# Sneak Circuit Analysis of F-4C Flight Control System

DOCUMENT NO. D2-118545-1

MODEL NO. F-4C CONTRACT NO. F33657-74-C-0686

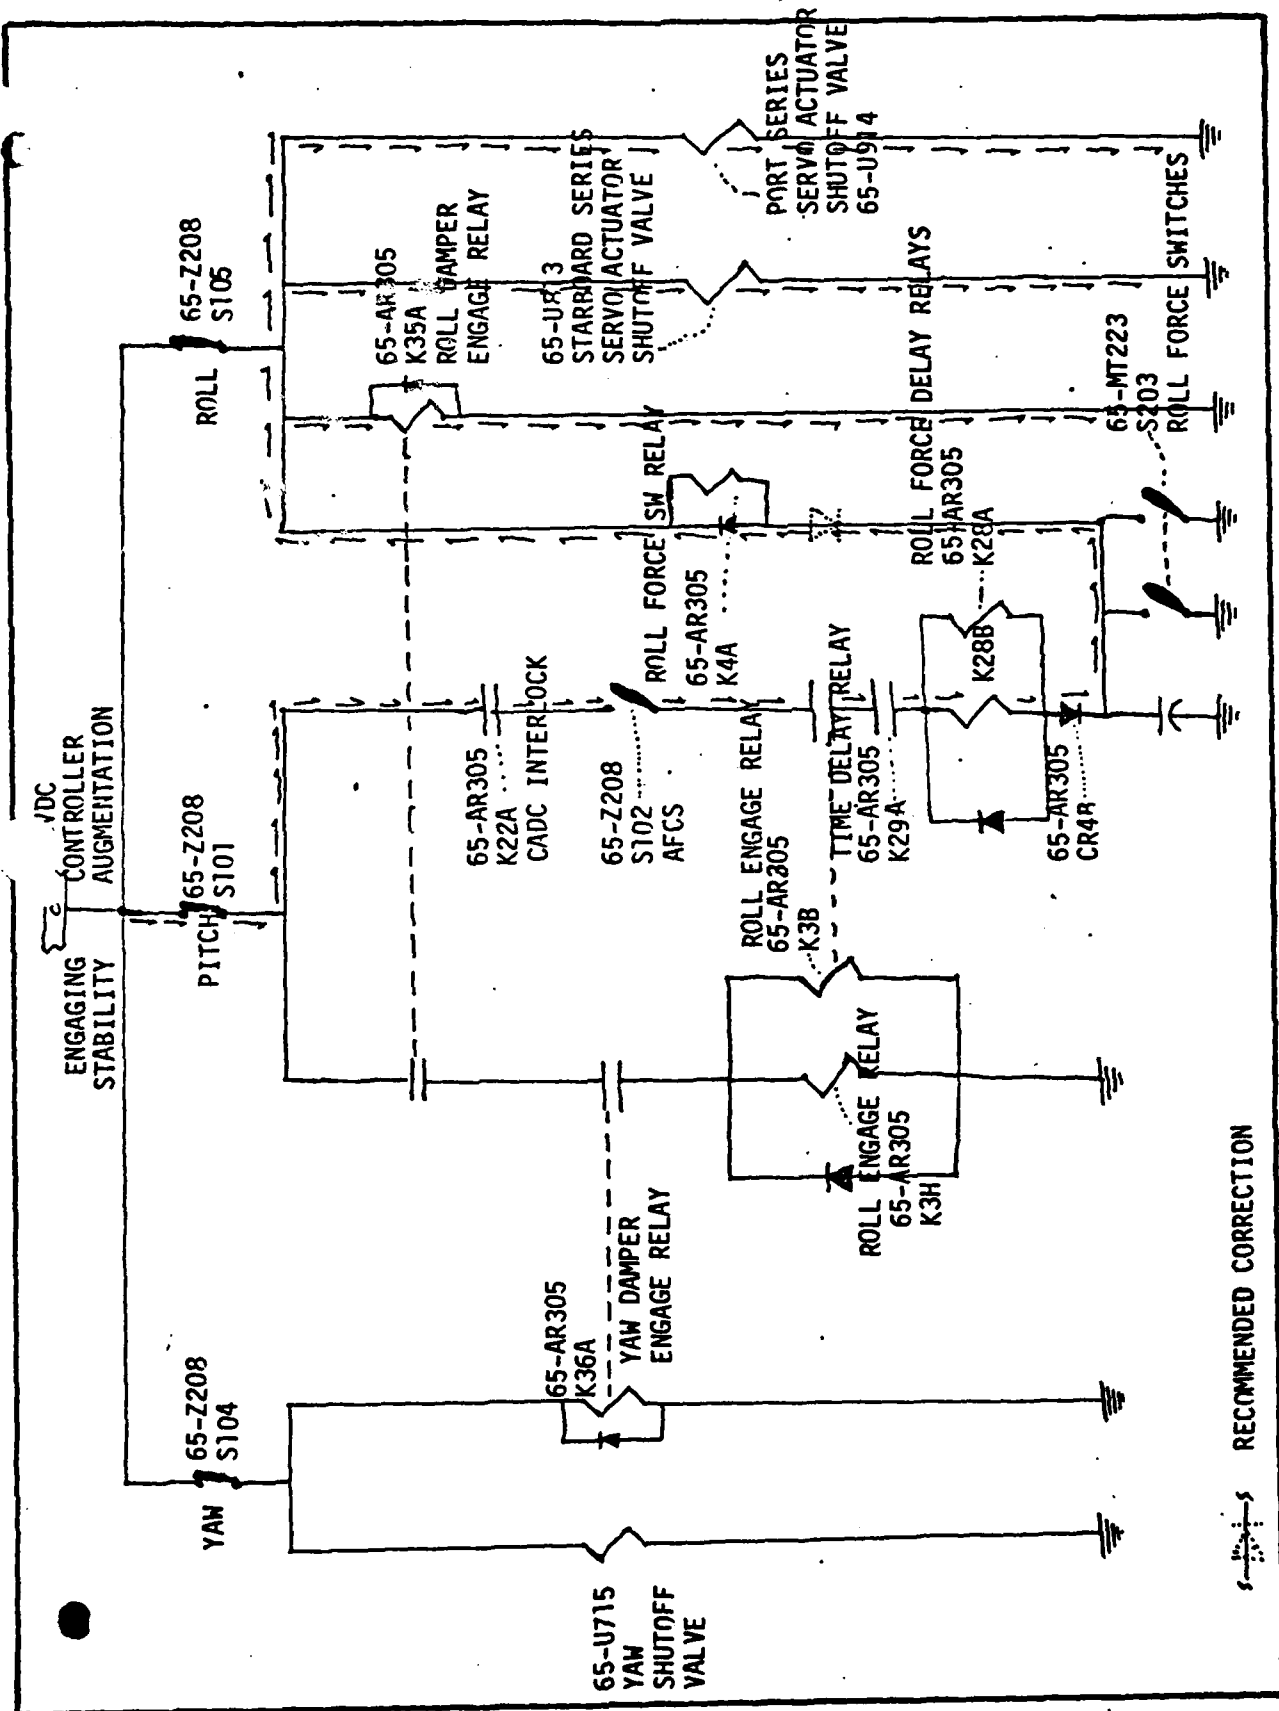
When the Pitch (S101), YAW (S104), and Roll (S105) Stability Augmentation Switches in ref. des. 65-Z208 and when the AFCS (S102) switch in ref. des. 65-Z208 are closed and when the CADC Interlock Relay (K22A) is energized by applying power to the autopilot, and the Time Delay Relay (K29A) is energized by closing switch S102, power will be established thru the Roll Force Delay Relays (K28A and K28B) in ref. des. 65-AR305. If the Roll Force Switches (S203) in ref. des. 65-MT223 are open and S105 is then opened, current can flow thru the suppression diode of the Roll Force Switch Relay (K4A) and can flow to ground thru the Roll Damper Engage Relay and the Port and Starboard Series Servo Actuator Shutoff Valves.

This condition is terminated less than one second after S105 is opened by K29A contacts opening.

Add a diode in the location shown.

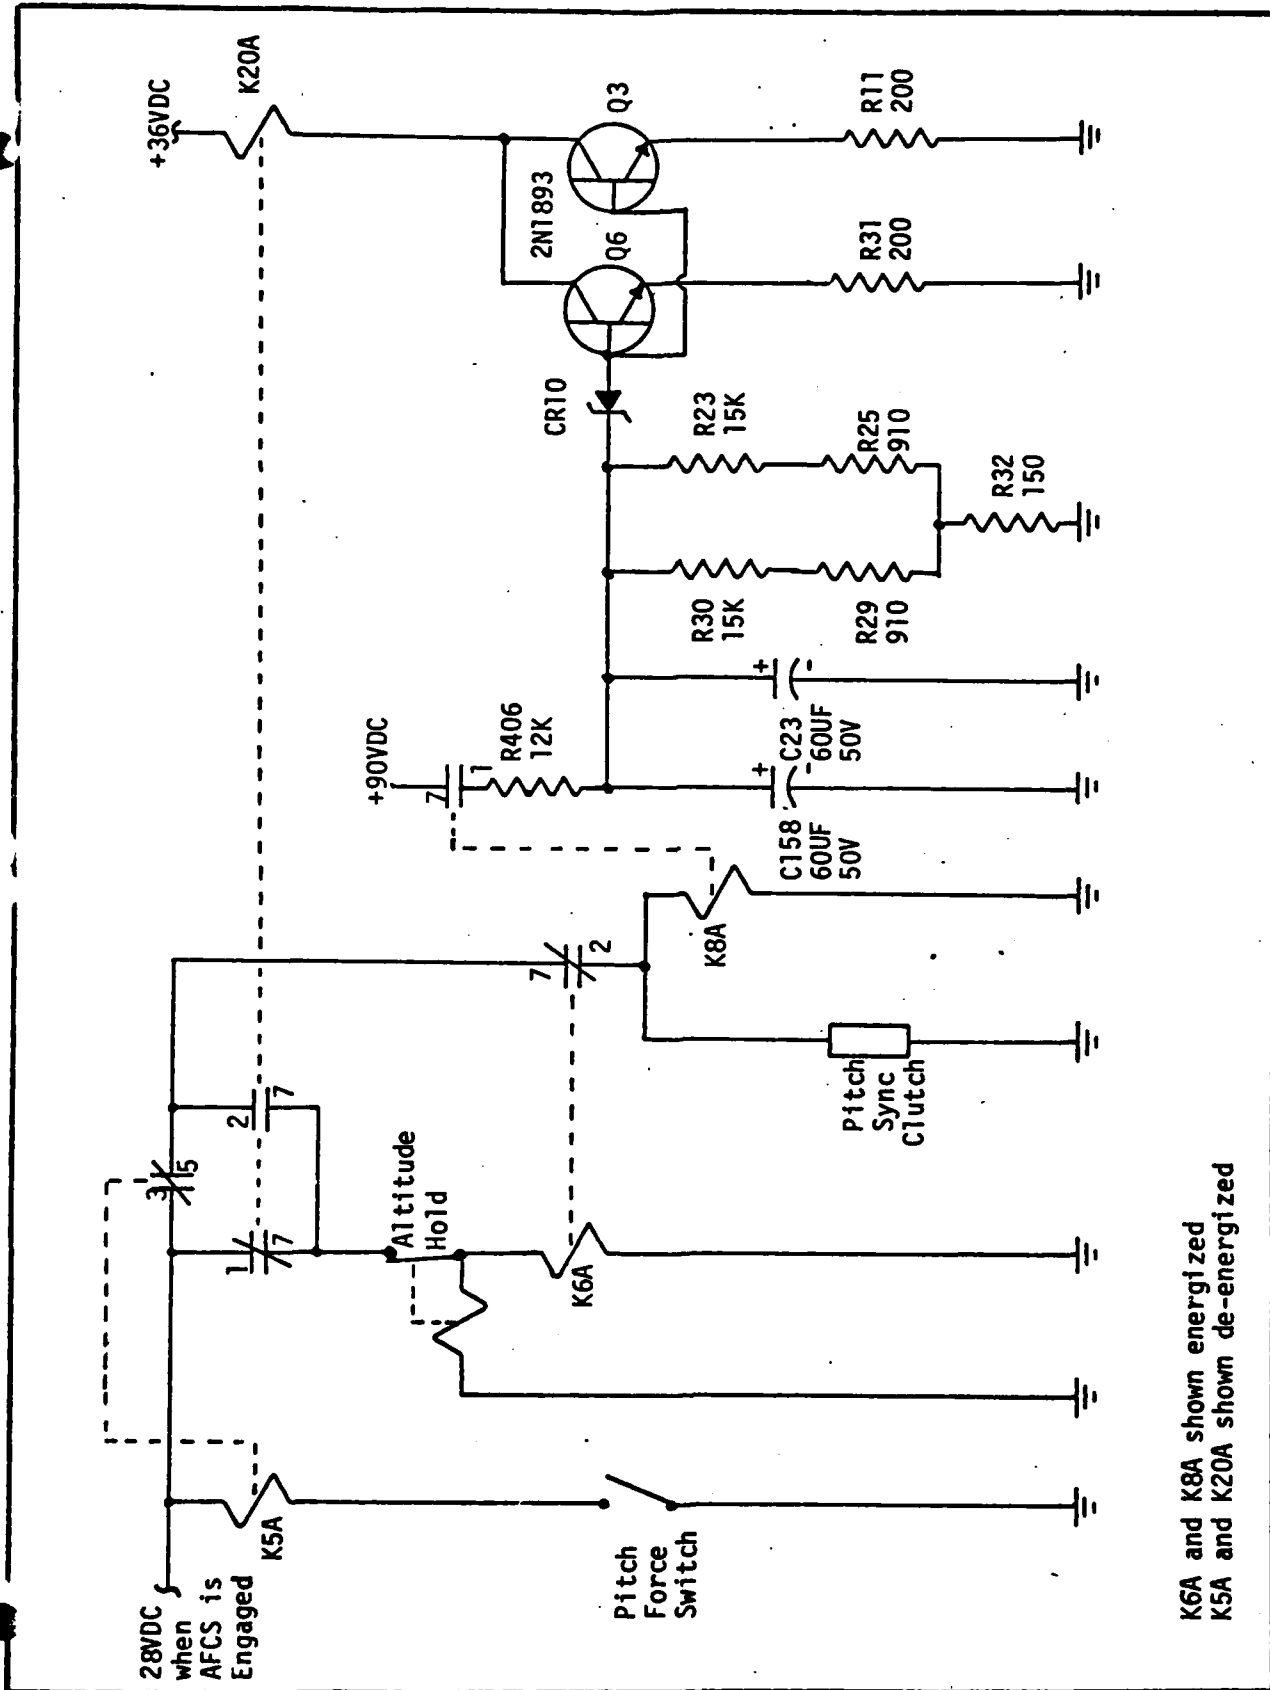
The Pitch Force Switch is closed during pilot controlled pitch maneuvers. Closing Pitch Force Switch, with Altitude Hold Engaged, energizes K5A, which opens K5A contact pins 3 and 5. This de-energizes K8A which reapplies 90 volts to the Adder Attenuator Circuitry. After C158 and C23 are charged to approximately 21 volts, a path to ground is completed for K20A. With K20A energized, K20A contact pins 2 and 7 close and contact pins 1 and 7 open. This interrupts voltage to the holding relay for the Altitude Hold Switch, which drops out.

If the Pitch Force Switch is opened before C158 and C23 have been fully charged, then K20A will not energize and Altitude Hold will remain engaged.

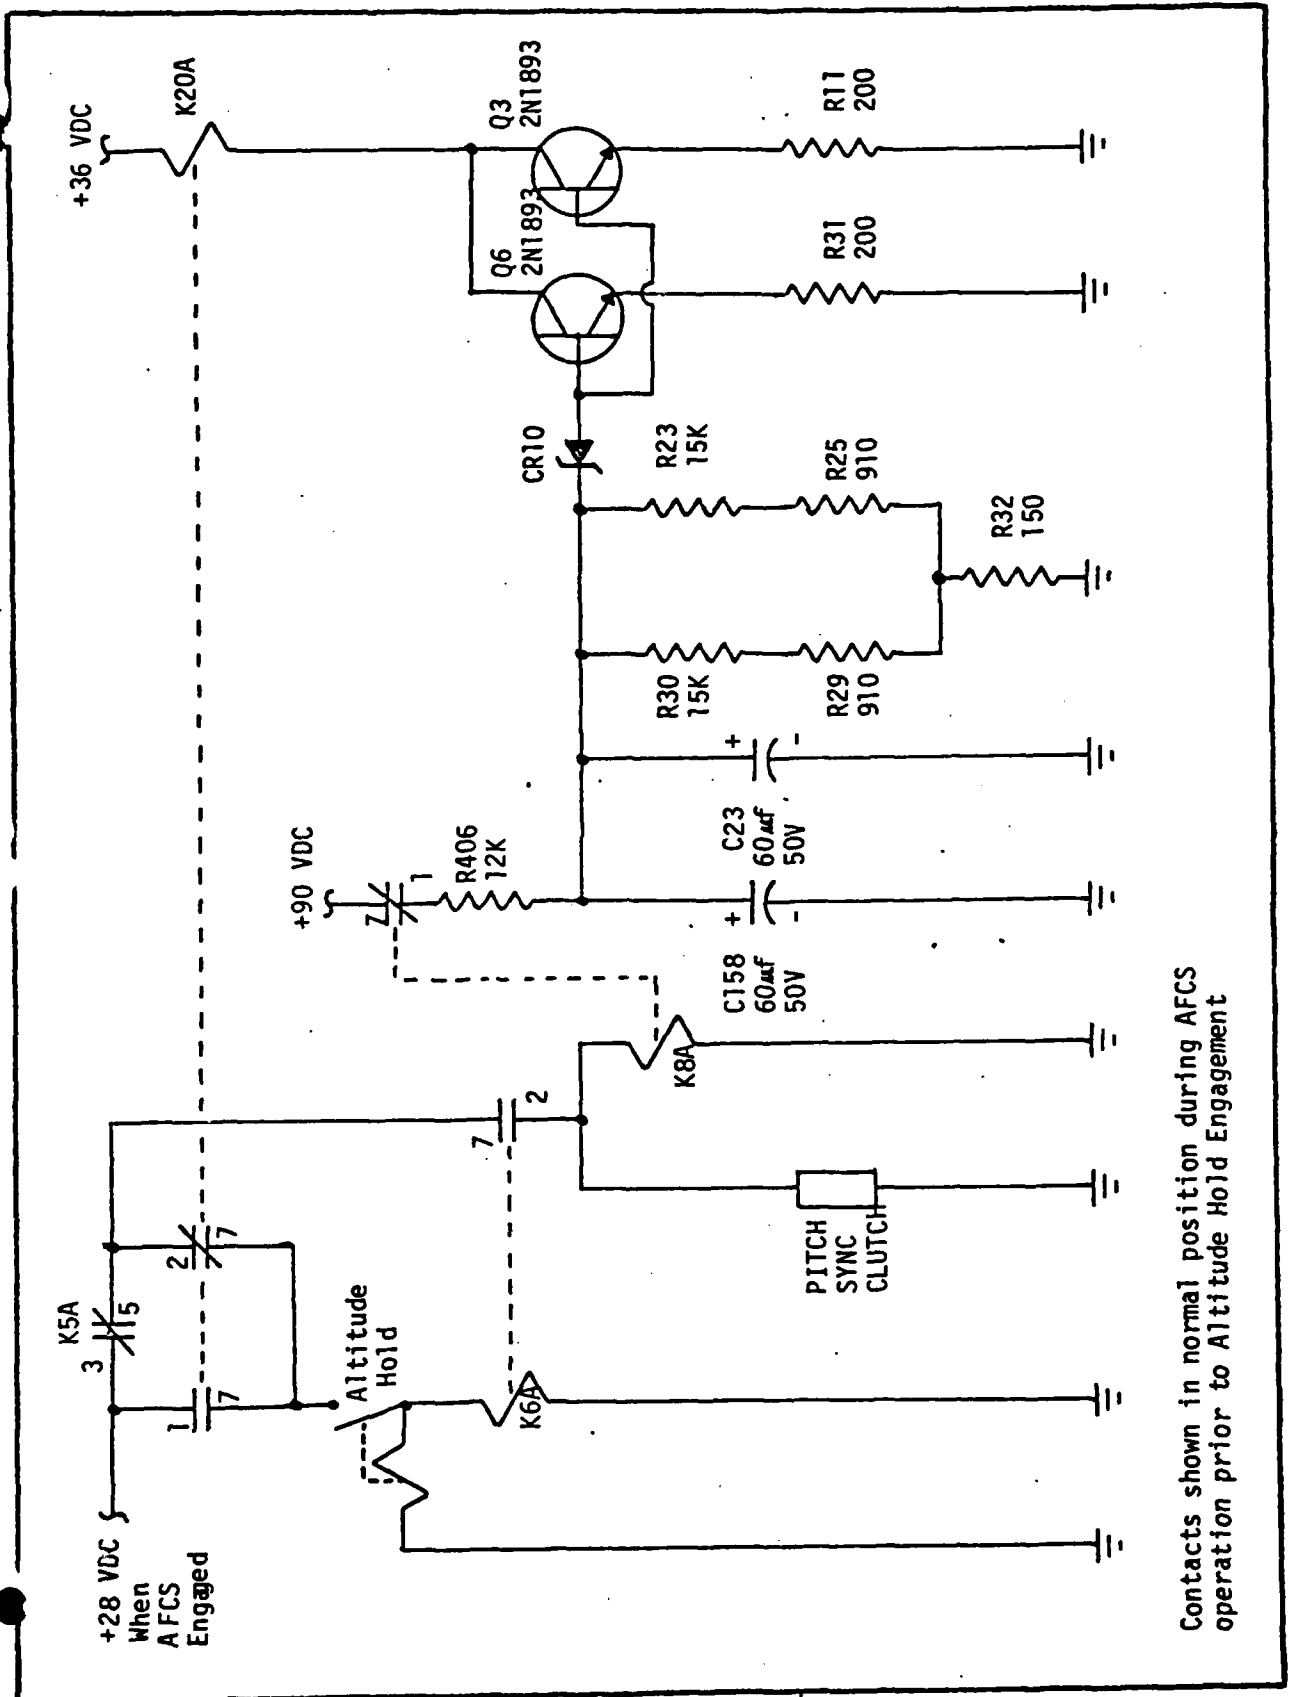
When Altitude Hold Switch is engaged, K6A energizes and closes contact Pins 2 and 7. When K8A energizes and opens contact Pins 1 and 7, thus removing the 90 VDC from the Adder Attenuator. After C158 and C23 discharge below approximately 21 volts transistor Q3 and Q6 turn off and K20A loses its path to ground and de-energizes. When K20A de-energizes K20A contact Pins 1 and 7 close and K20A contact Pins 2 and 7 open. When these contacts are switching, the Altitude Hold Engage switch loses voltage to its holding coil.

Replace relay K20A with a relay with make before break contacts.

Figure 1  
STABILATOR FEEL TRIM  
ACTUATOR

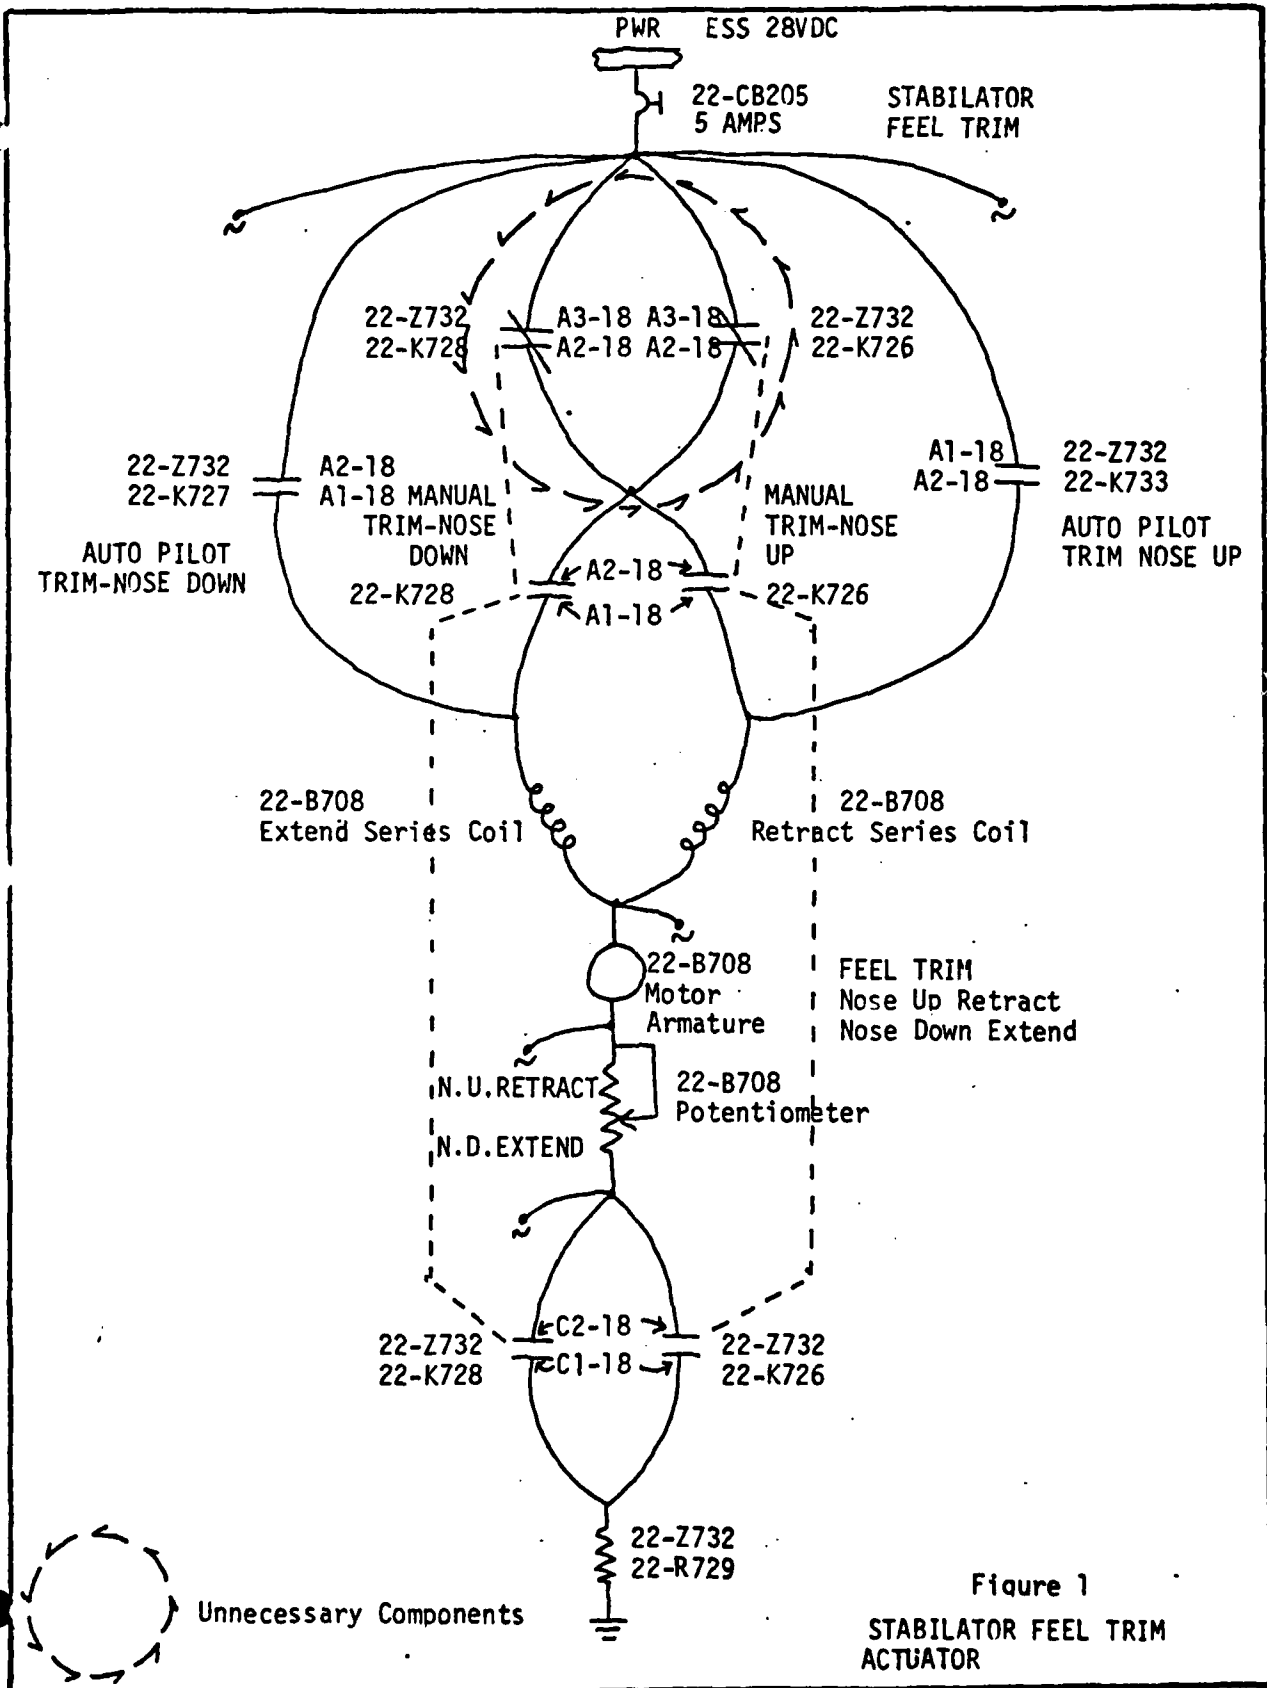
The Manual Trim-Nose Up Relay (22-K726) and the Manual Trim-Nose Down Relay (22-K728), shown in Figure 1, cannot be energized at the same time. Therefore, the normally closed contacts (A3-18/A2-18) of either 22-K726 or 22-K728 will provide continuity from Circuit Breaker 22-CB205 to the normally open contacts (A2-18/A1-18) of 22-K726 and 22-K728.

Thus, the normally closed contacts (A3-18/A2-18) of 22-K726 and 22-K728 provide unnecessary switching.

Delete the normally closed contacts (A3-18/A2-18) of 22-K726 and 22-K728 and replace them with continuity.
